Service Bulletin

SB Number:	SB 2AV-013	Issue Date: 18/07/2001
Subject:	Improvement of paper conveyance	
Model:	KM-1530 / 2030, KM-1525 (ST-12)

'STATIC ELIMINATOR, CASSETTE PAPER FEED'

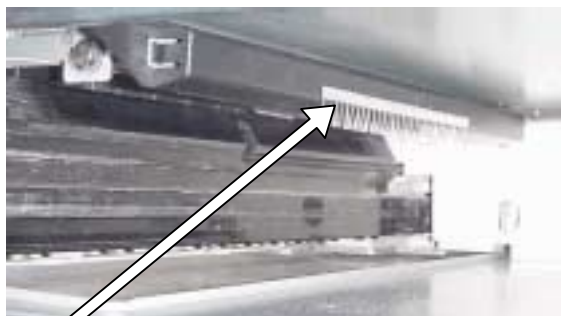
- **‘STATIC ELIMINATOR, CASSETTE PAPER FEED’** has been added to prevent paper jams due to static electricity)
- **‘FILM, GUIDE CONVEYING’** has been added to prevent paper feed jams on the KM-2030.

'STATIC ELIMINATOR, CASSETTE PAPER FEED'
(length: 154 mm)

Please install the newly added parts when necessary.

'FILM, GUIDE CONVEYING' (only for KM-2030)

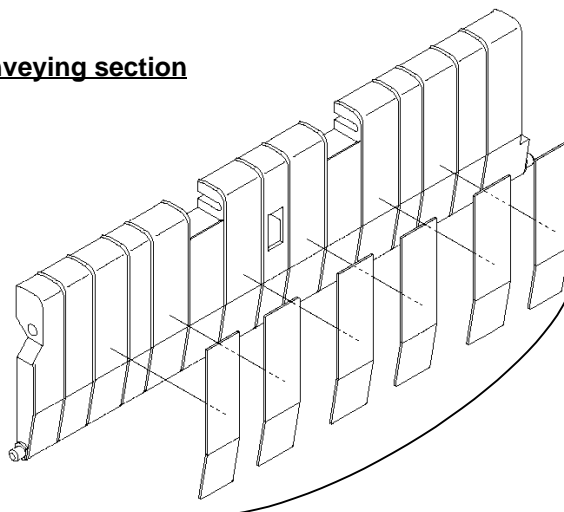
'FILM, GUIDE CONVEYING' x 6
(Black conductive sheet attached to 'GUIDE, CONVEYING')
